Madison and Gunderson Place
435 Madison Street
Oak Park, Illinois 60302

PD Application - amended Item 1

NARRATIVE - revised 2/27/20

Development Drawings revised 2/24/20
revised 2/27/20

1 SITE PLAN
SCALE: 3/64" = 1'-0"

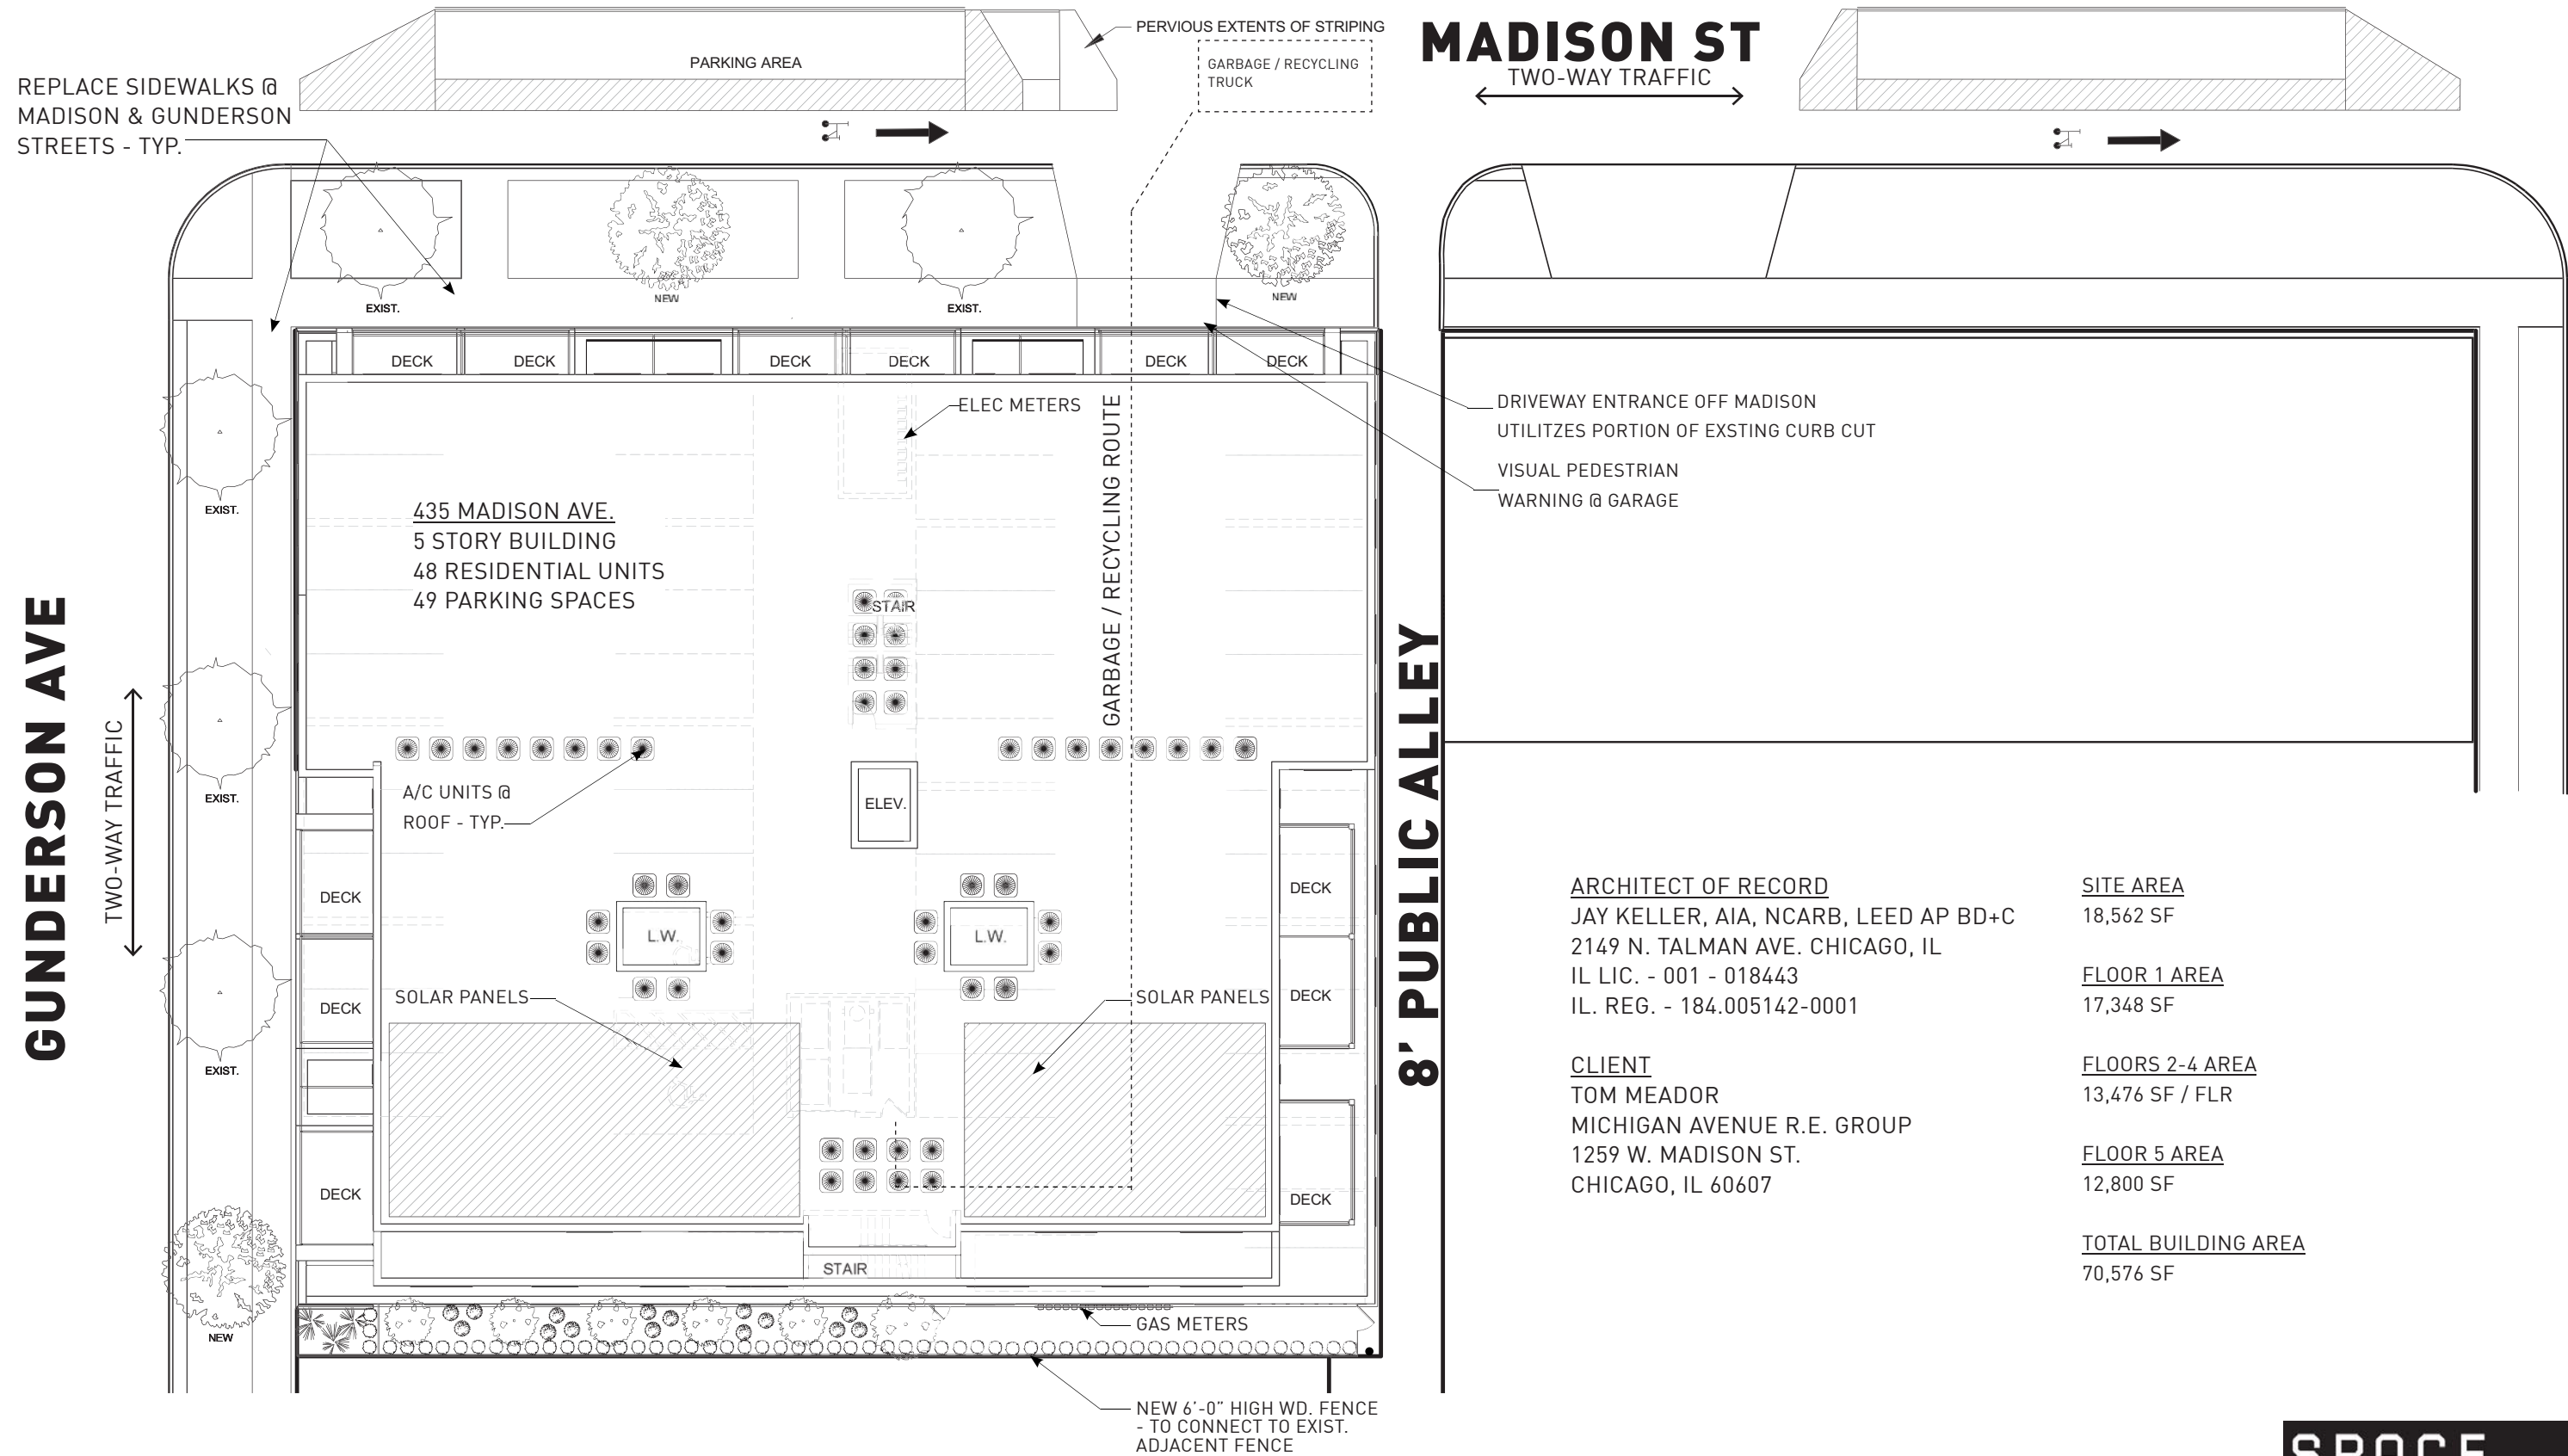
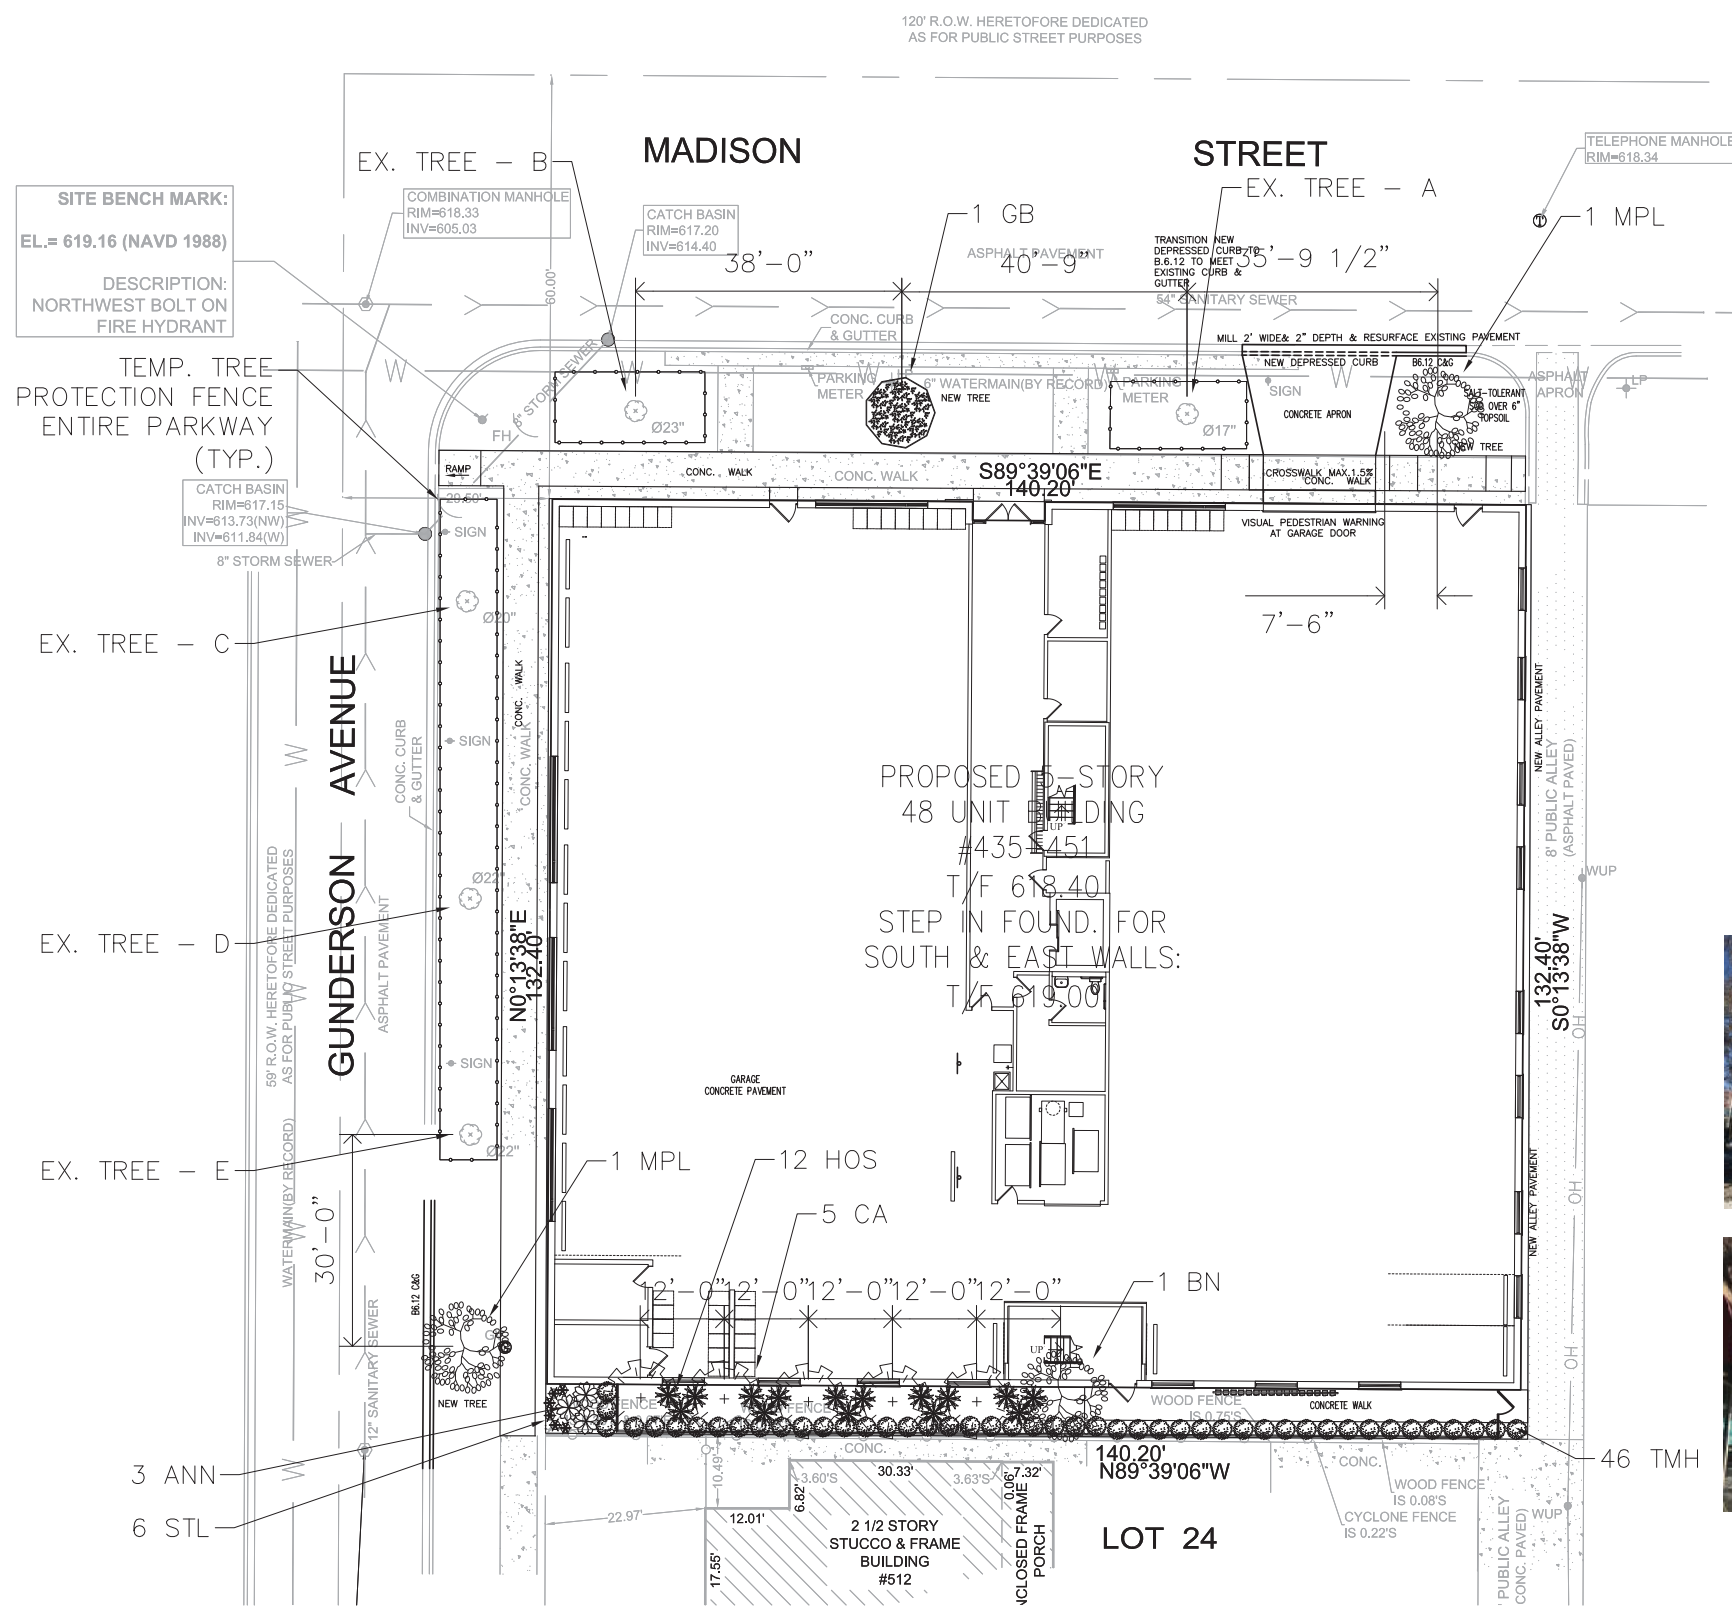
1. Redesign of the proposed building
See the revised architectural plans, elevations and rendering.
2. Vehicle entrance moved to Madison Street
See the revised site plan and landscaping plan.
3. Building massing refinements at the South building façade
See the revised rendering and elevations.
4. Addition of green space and landscaping
See the revised Landscaping Plan.
5. Additional traffic counts and Parking Studies
See the revised Traffic Study and Parking Recommendations.
6. Addition of a building mural at street level
See the revised rendering.
7. Correction to the Market Analysis Report
See the Letter by HollyAnn Eageny from Tracy Cross and Associates.

435 MADISON AVE.
5 STORY BUILDING
48 RESIDENTIAL UNITS
49 PARKING SPACES
